**ARLINGTON COUNTY, VIRGINIA
AGREEMENT No. 20-110-9-6**

AMENDMENT NUMBER 6

**Ballston-MU Station Area Improvements Project
MEMORANDUM OF NEGOTIATIONS**

CHANGE ORDER No. 12 – Add eight (8) new items: Asphalt Price Escalation; Flag Sign Relocation; Concrete Fill Behind Bank of America Stairs; Curb Ramp (CR) No. 3 Modification; Planter 1-4 Core-Drilling for Drainage; Planter 9-10 Tree Trimming; Additional Work @ Various Locations; and Non-compensable Time Extension.

Planter Measurements

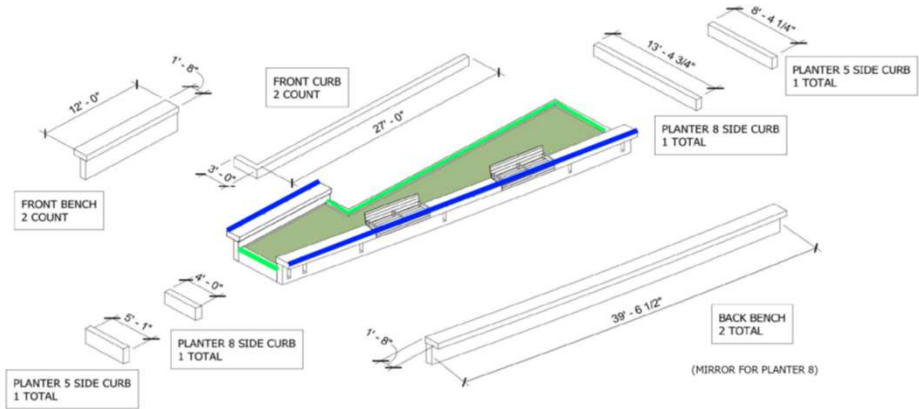
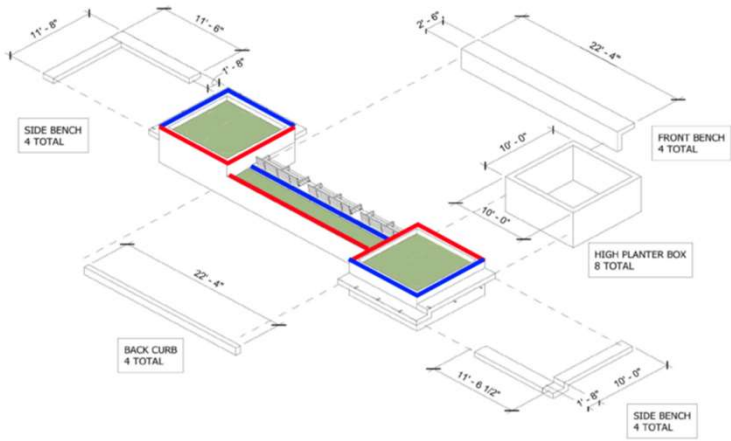
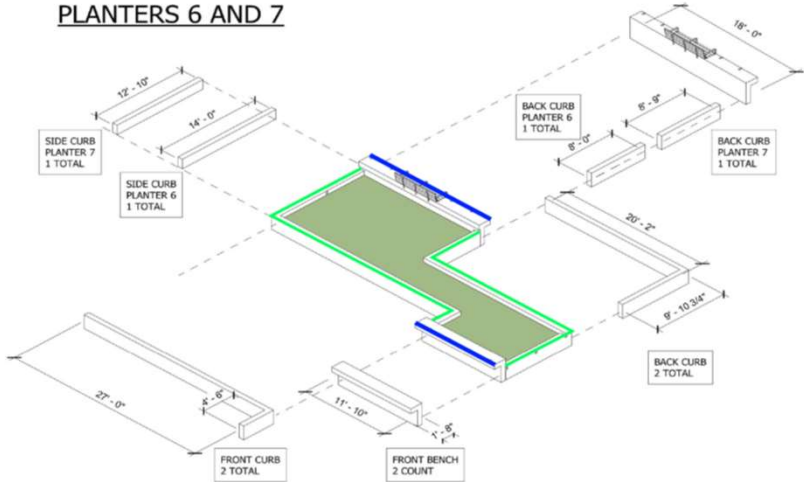
- Reason for Change Order: Upon installation of Planters 1-4 and adjacent sidewalk along N. Stuart St., considerable water puddling occurred after rain events atop the sidewalk under Planter 1 and 2 benches facing east. In order to mitigate this issue and avoid slipping hazards during the winter season, the County directed Ardent to core drill drain holes through the planter pre-cast sections at all four (4) planters and install pipe connections to the existing planter underdrain piping. As a result, Ardent was requested to submit a cost proposal for this new item.

CR-3

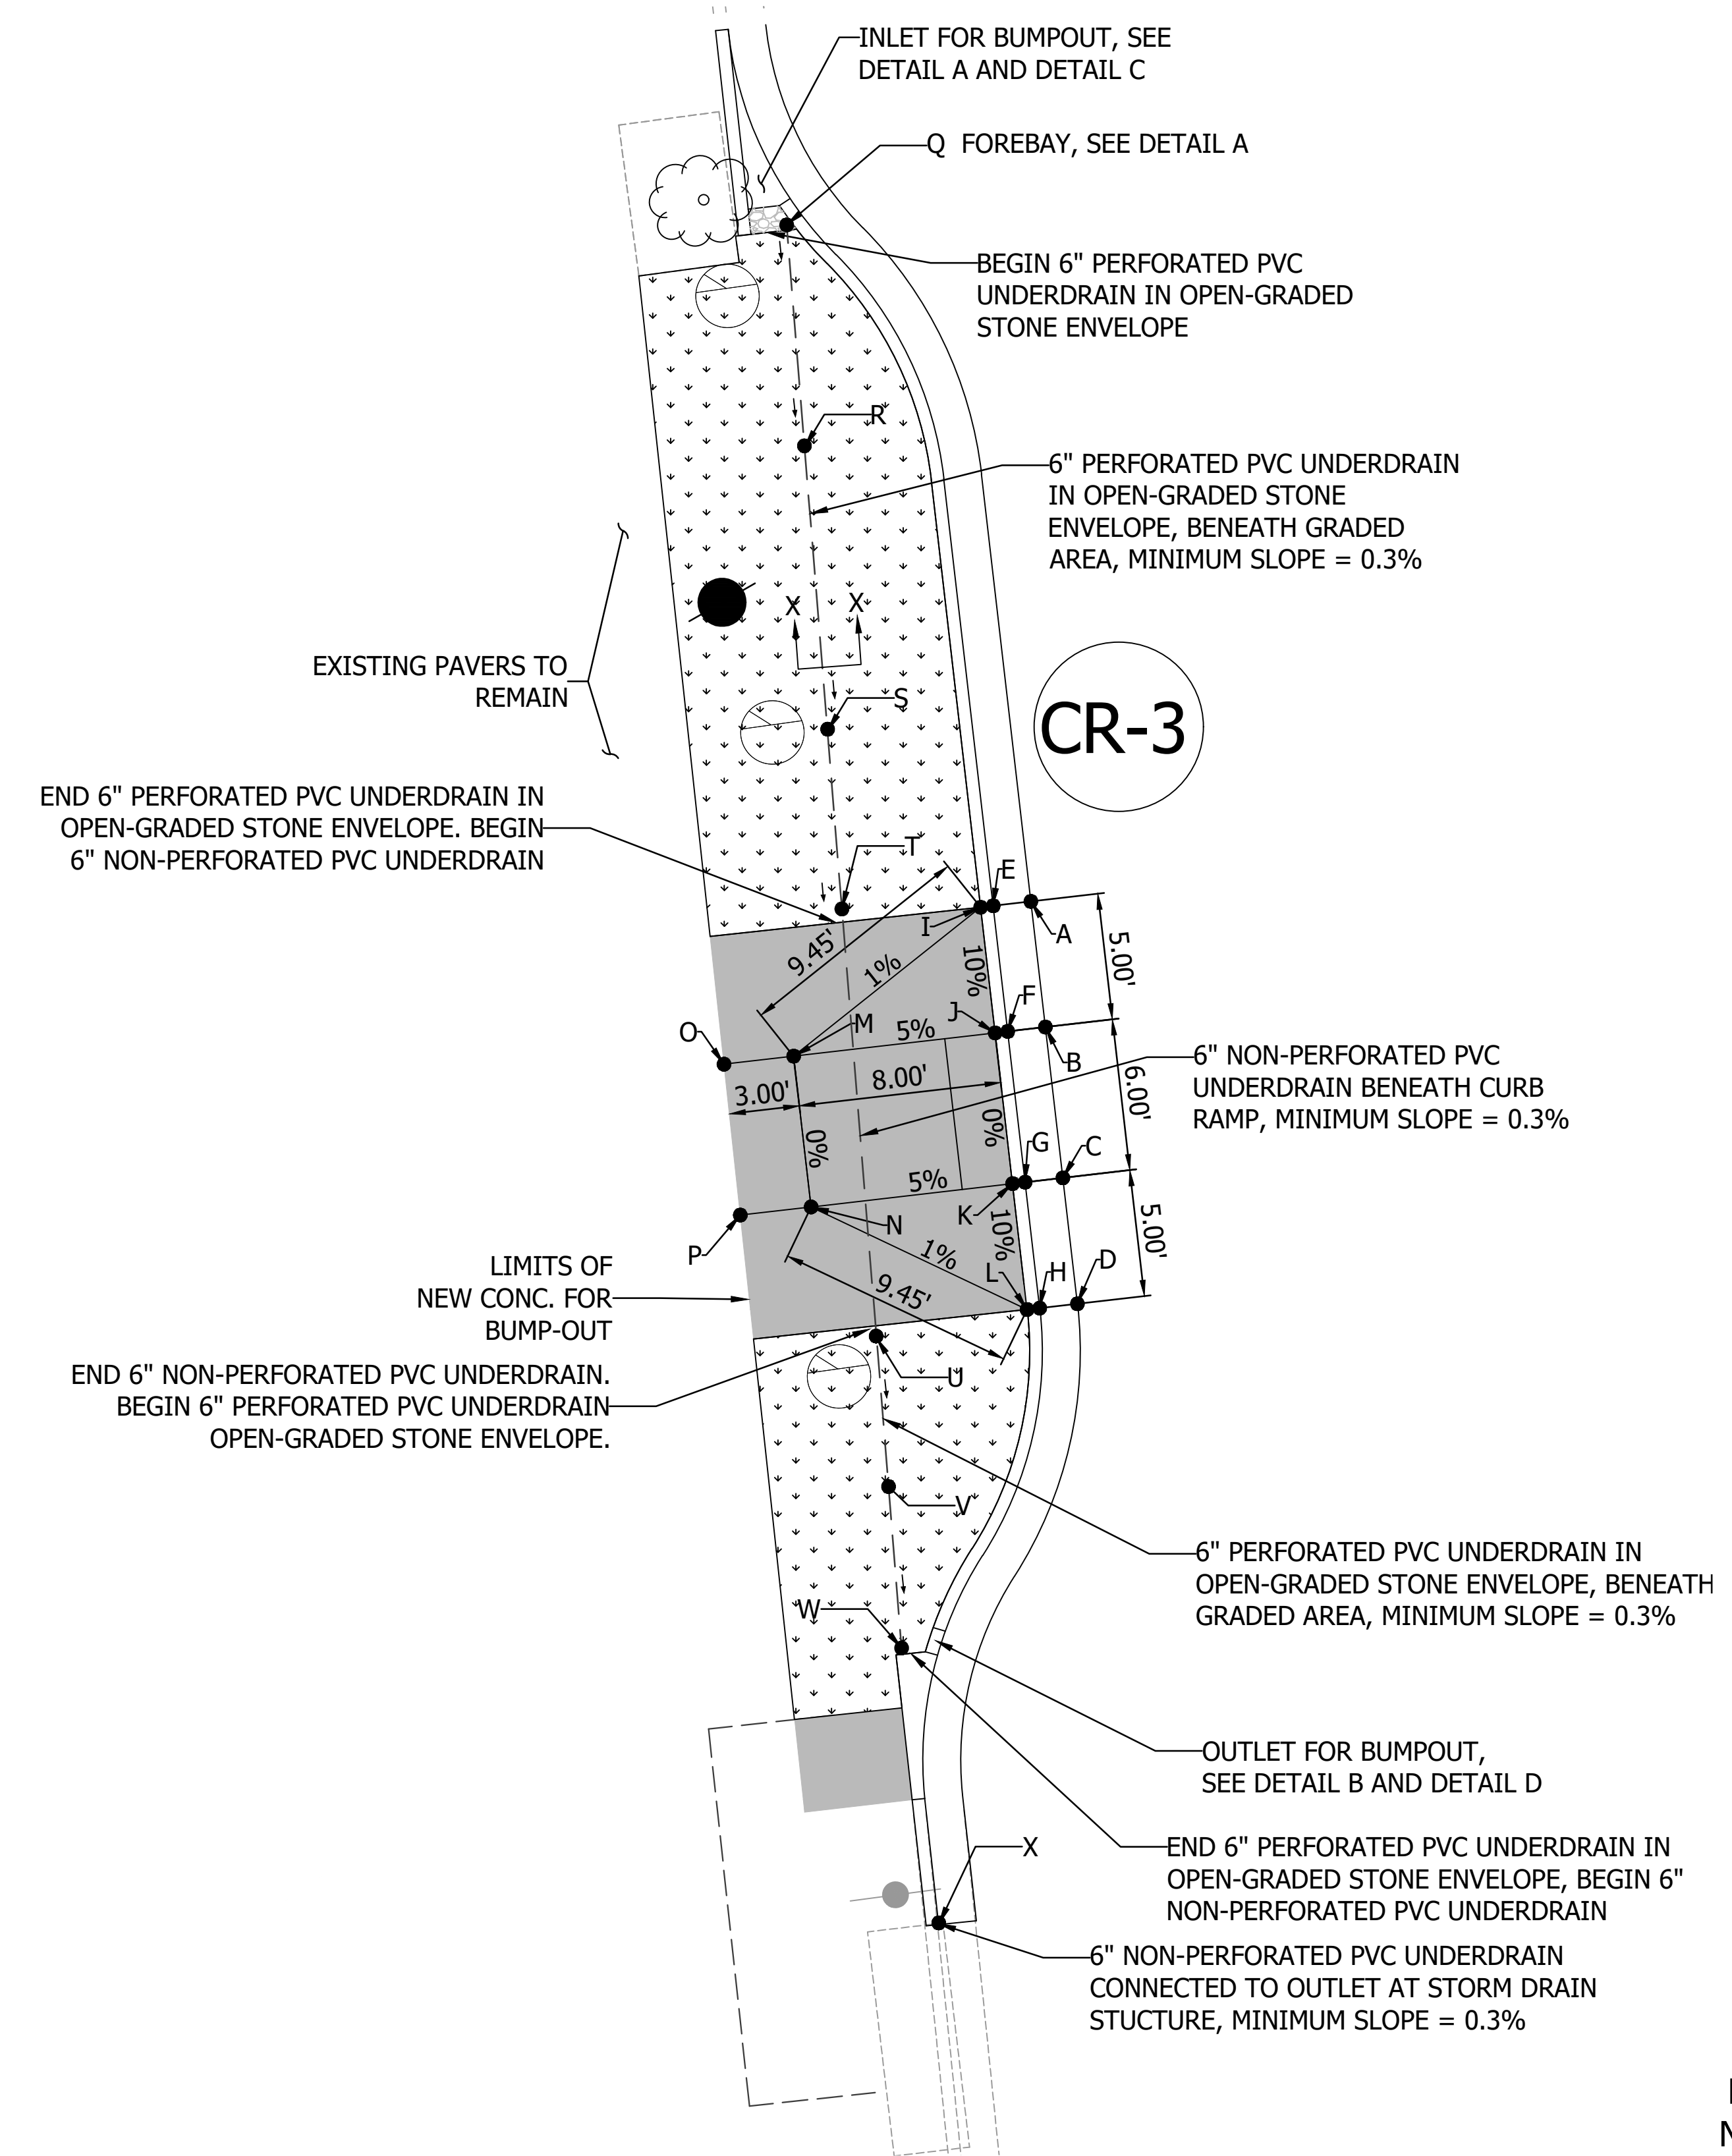
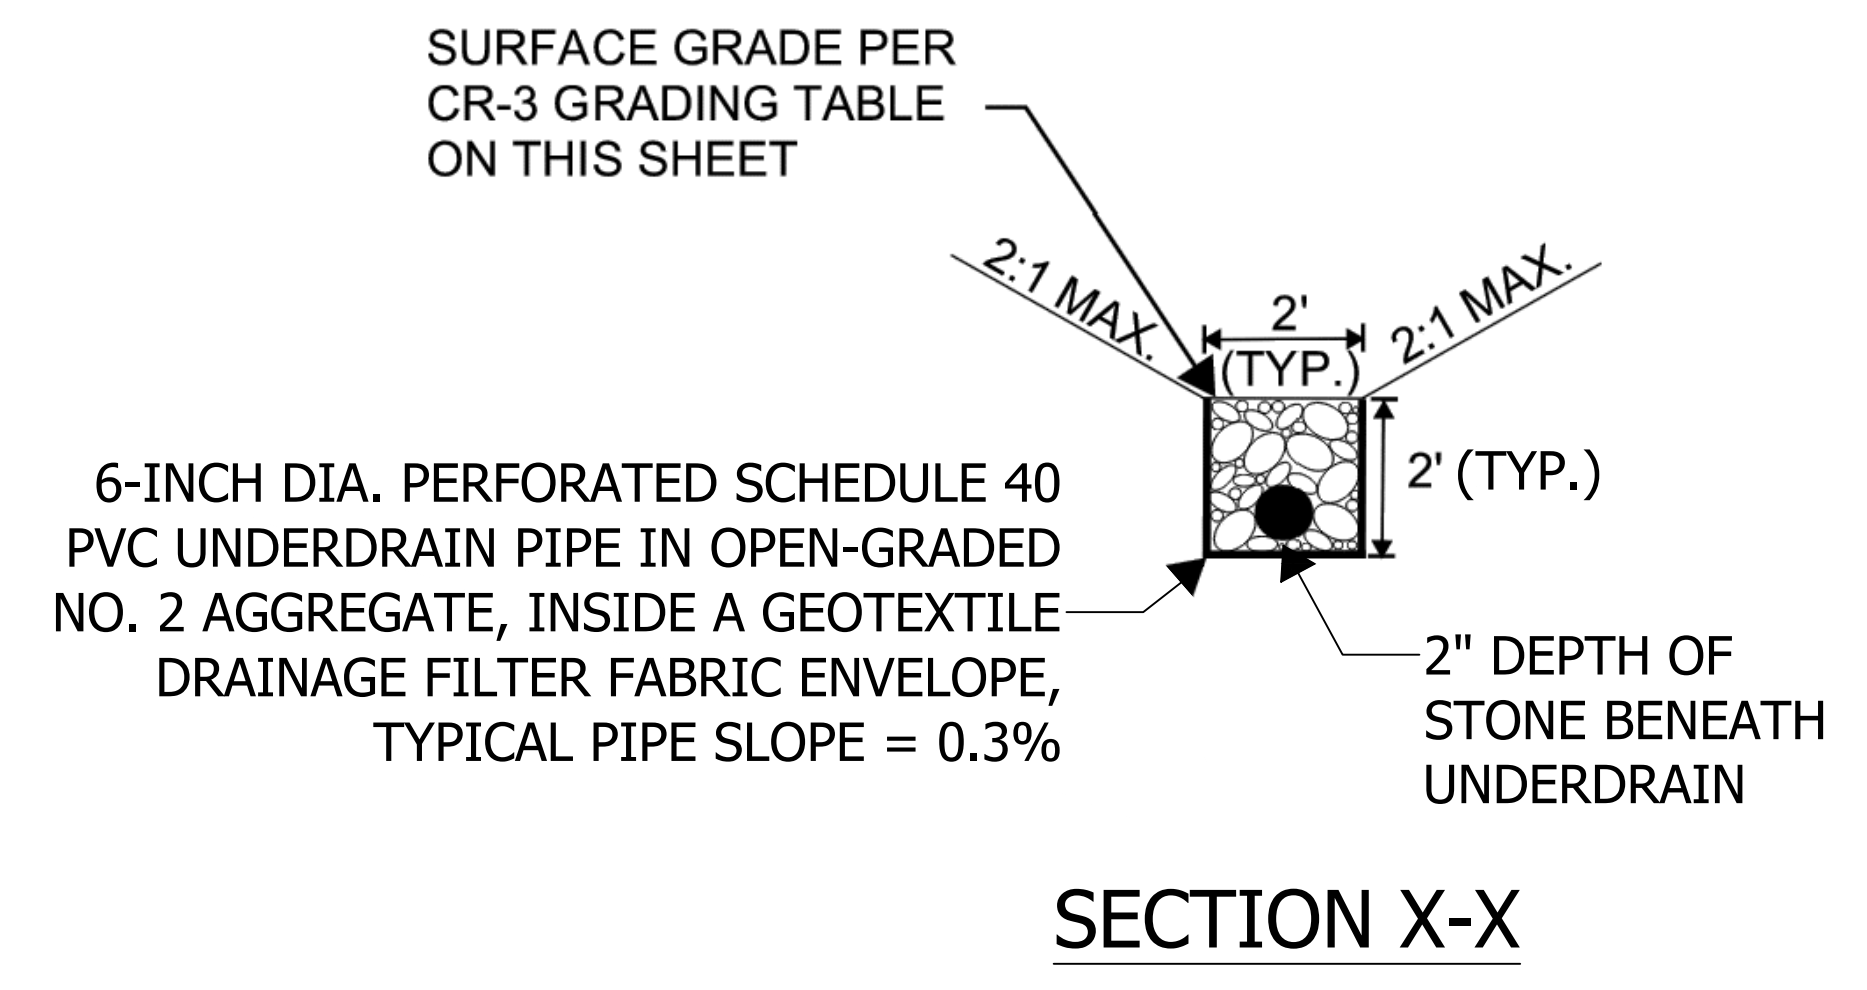
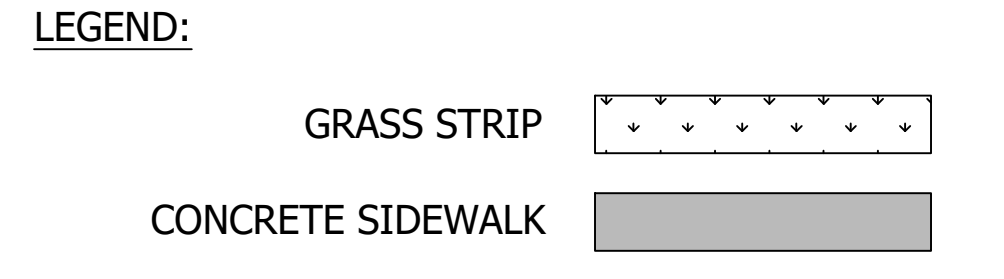
- Reason for Change Order: During a field-check prior to constructing CR-3, it was determined that puddling would occur in sidewalk areas behind the curb if it were built per design because the new curb top elevation would be higher than the existing curb. After further coordination with the County's WSS department and in response to RFI No. 53, the designer (Parsons) eliminated the concrete sidewalk in the bump-out and replaced the impervious area there with a landscaping strip consisting of ornamental grasses and other landscaping features. This redesign would

Attached are the revised plan and details for CR-3 to place a grass buffer strip with curb cuts.

1. Eliminate the concrete sidewalk in the bumpout and replace the impervious area with a landscaping strip. We can keep the 6" curb and the ADA ramp and the rest of the bumpout can be planted with ornamental grasses or other landscaping features. This option would create a low spot at the northern edge of the bumpout, which we would address with a curb cut, similar to the attached DDOT standard. We would install riprap on the northern edge, to mitigate erosion concerns, and the outlet at the southern edge would release any excess water to the inlet nearby. The DDOT standard is only being referenced for the curb cut detail and not the bioretention usage.

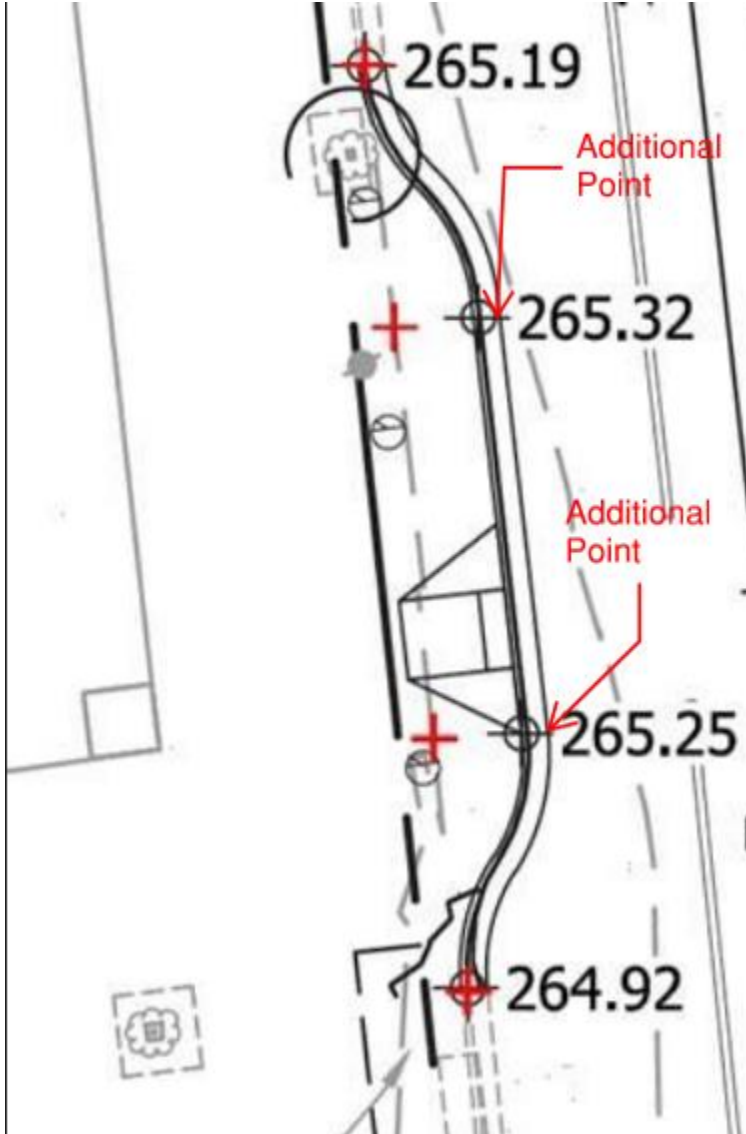
James,
Please find the attached pdf with elevations.

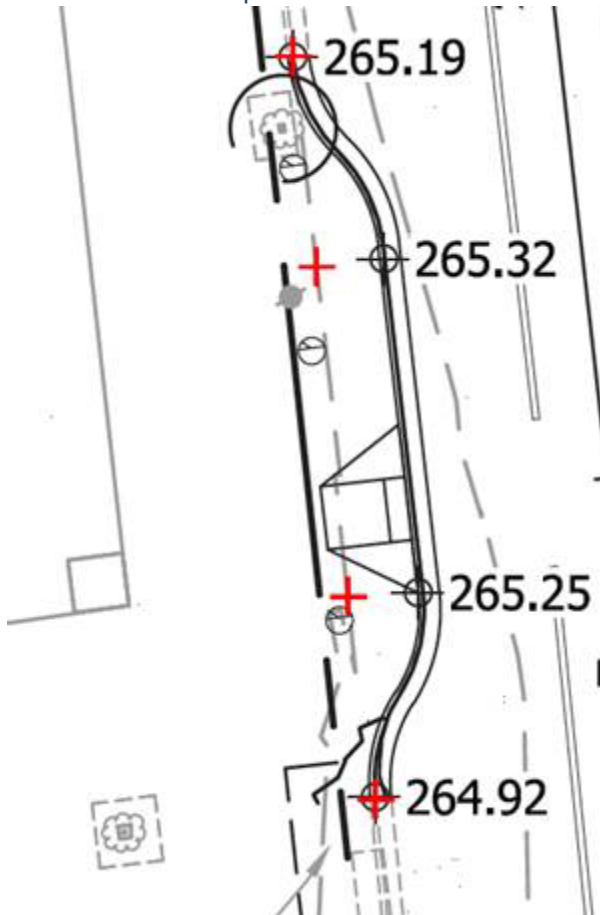
Sekander - I will have to ask the surveyor to come out and take some elevations. He may charge couple of hundreds, should not be that much.
James- Will these 4 points work?
